KEMPER
VALVE & FITTINGS CORPORATION

Kemper Valve and Fittings began providing a revised version of the 2” 602 Female in September of 2009.

Reduction of Thread Major Diameter in New Engineering Design is Illustrated by Comparing the Original Design Major Diameter (on left with no raised shoulder) to the Reduced Major Diameter (on right with raised shoulder).

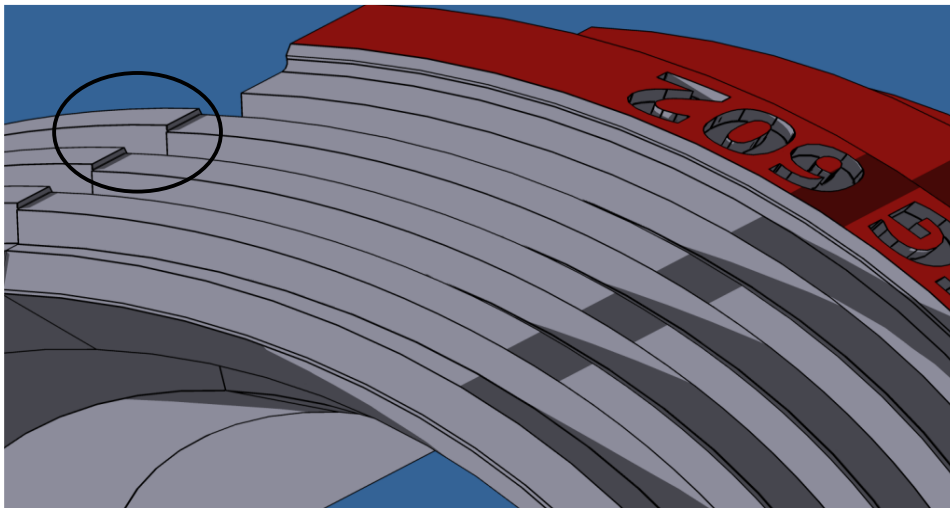
It will prevent make up with a 2” 1502 Nut. Prior to the revision, the industry standard for this part allowed for a minor overlap of the threads between the 2” 602 Female and the 2” 1502 Nut. This minor overlap could cause a false impression that the union was made up and pressure tight when, in fact, it was not. A make up of these mismatched threads could fail explosively – potentially causing serious injury to anyone nearby if the assembly failed.

With the revised 2” 602 Female, the minor overlap has been eliminated – preventing make up with a 2” 1502 nut. The revised version of the 2” 602 female has a truncated thread (see picture below) and a shoulder immediately behind the threads on which the designation “2” FIG 602” is stamped.
